# UNITED STATES PATENT AND TRADEMARK OFFICE

APPLICATION NO.	FILING DATE	FIRST NAMED INVENTOR	ATTORNEY DOCKET NO.	CONFIRMATION NO.
10/619,273	07/14/2003	Patrick Gillen	07006.00011	6321
7590	09/01/2005		EXAMINER	
Steven Thrasher 391 Sandhill Dr. Richardson, TX 75080			CECIL, TERRY K	
			ART UNIT	PAPER NUMBER
			1723	
DATE MAILED: 09/01/2005

**Office Action Summary**

## DETAILED ACTION

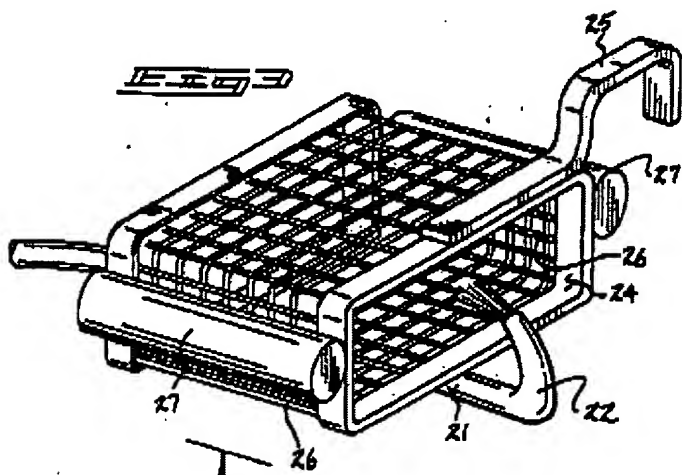
6. Claims 1-2, 4-5 and 8 are rejected under 35 U.S.C. 102(b) as being anticipated by Weiss (U.S. 5,279,728). Weiss teaches a static pool skimmer including a mounting portion adapted to

mount onto the rail of an above ground pool (figure 2); a collecting portion (24, 26); a coupling portion therebetween (the horizontal portion of 25 attached the frame of the collecting portion); and a debris directing means (either 22 or the 2<sup>nd</sup>

float 27 mounted adjacent element 25) [as in claims 1-2]. The collecting means includes a net 32 (fig. 8) [as in claim 5] and a frame having a floatation member (the 1<sup>st</sup> float 27) and the claimed arms [as in claim 4]. As for claim 8, the elements shown in figure 3 (including the 2<sup>nd</sup> float and the debris jet 21,22) attached together and acting as a unit is sufficient to anticipate “integrally-formed”.

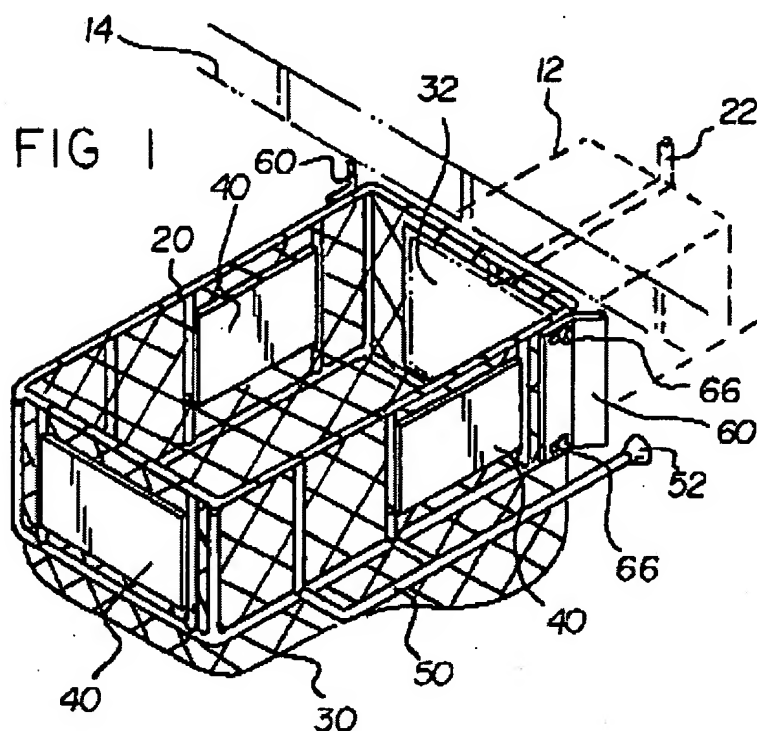
7. Claims 1, 7 and 9 are rejected under 35 U.S.C. 102(b) as being anticipated by Anderson (U.S. 5,833,845). Anderson teaches a static pool skimmer including a mounting portion (hook

22 or suction cups 52); a collecting portion 20/30; a coupling means coupling the mounting and collecting portions (either the vertical portion of 22 attached to the frame 20 or element 50 attached to the suction cups 52); and a debris directing means (either 60 or doors 40) [as in claim 1].

The debris directing means 60 is adapted to removably attach to frame 20 [as in claim 7] and the debris directing means 40 comprises an orifice surrounded by a collecting means [as in claim 9].

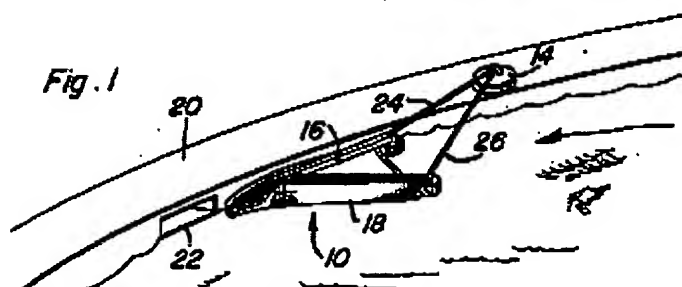
8. Claims 1, 4-5 and 8 are rejected under 35 U.S.C. 102(b) as being anticipated by Sermons (U.S. 4,089,074). Sermons teaches a static pool skimmer including a mounting means 14;

a coupling means 24, 26; a collecting means 18 including a net; and a float (considered integral) adjacent the pool wall that acts to divert debris into the

collecting means openings [as in claims 1, 4-5 and 8].

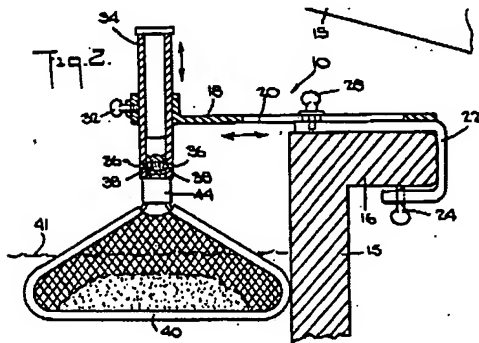
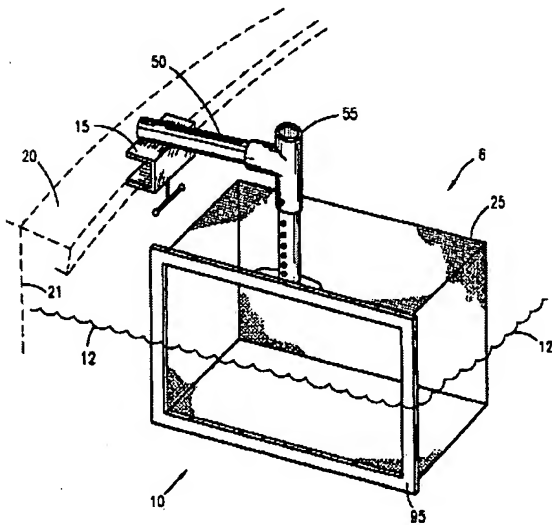
9. Claims 1-3 and 8 are rejected under 35 U.S.C. 102(b) as being clearly anticipated by either Baer (U.S. 6,398,952) or McFarland (U.S. 5,173,181).

As shown by their drawings both Baer and McFarland teach all the limitations of claims 1-3 and 8. In addition, McFarland clearly teaches his skimmer for both above and in-ground pools (col. 5, lines 20-25). Because the mounting means of Baer is "universal",

the skimmer can be attached to both above and in-ground pools.

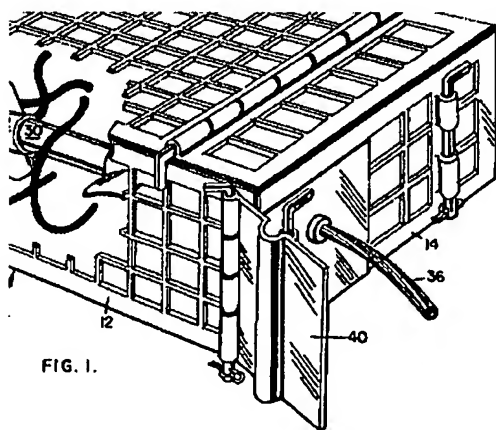
13. Claims 17-20 are rejected under 35 U.S.C. 103(a) as being unpatentable over the modified Anderson, as applied above, and in further view of Mendes (U.S. 5,779,392). The modified Anderson differs from that of claims 17-20 by requiring the debris directing means to be a clip and a flap. However, such a clip and flap 40 is taught by Mendes as shown below.

Mendes teaches a skimming device including a flap 40 connected to a collecting means by a securing means including a clip (at the bottom). It is considered that it would have been obvious to one ordinarily skilled in the art at the time of the invention to have the flap/clip of Mendes as the element 60 of the modified Anderson, since Mendes teaches the benefit of preventing material to be skimmed from entering areas that would bypass the collecting means (col. 6, lines 4-9). It also would have been obvious since the hinged configuration is more readily adjustable than the slot 62 of Anderson.

**FIG 2**

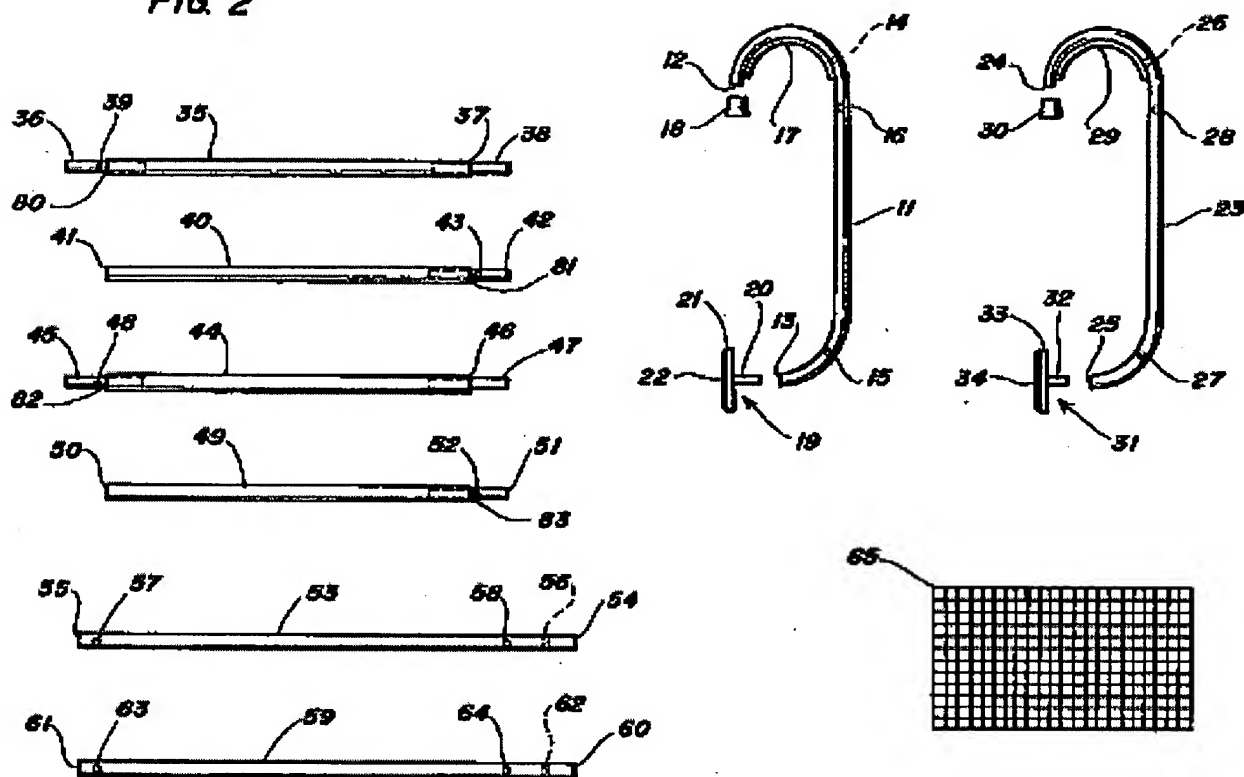
14. Claims 14 and 16 are rejected under 35 U.S.C. 103(a) as being unpatentable over the modified Anderson, as applied to claim 11, and in further view of Giacalone (U.S. 6,306,295). Giacalone teaches a skimmer wherein the collecting means includes a frame having hollow tubes and a net that is removable from the frame [as in claims 14 and 16]. It is considered that it would have been obvious to one ordinarily skilled in the art at the time of the invention to have the collecting means of the modified Anderson to be made of hollow tubes and the netting to be removable therefrom, as in Giacalone, since Giacalone teaches the benefit of be completely disassembled in to a compact form when not to be used for long periods of time. It is also

obvious for the netting to be removable from the frame in order to replace the netting when necessary.
